Notice of Allowability

10/733,138

GODEFROID, ALAIN JOSEE
JOSEPH

Examiner's Amendment

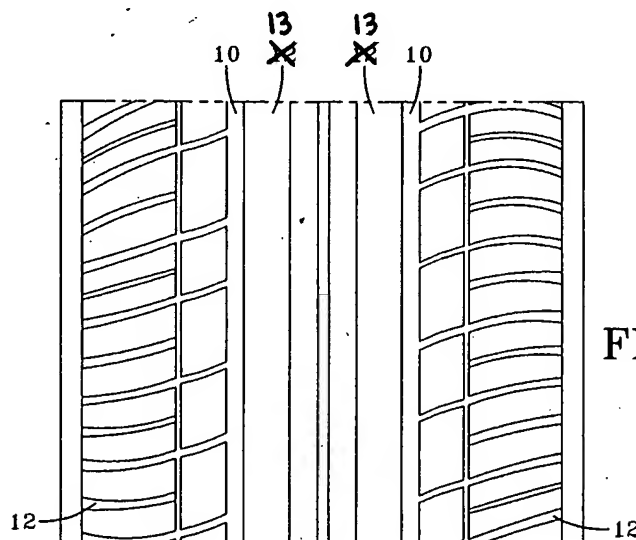
Amend figure 1 as follows: At the top of figure 1, change both occurrences of "12" to --13--. These changes are indicated below:
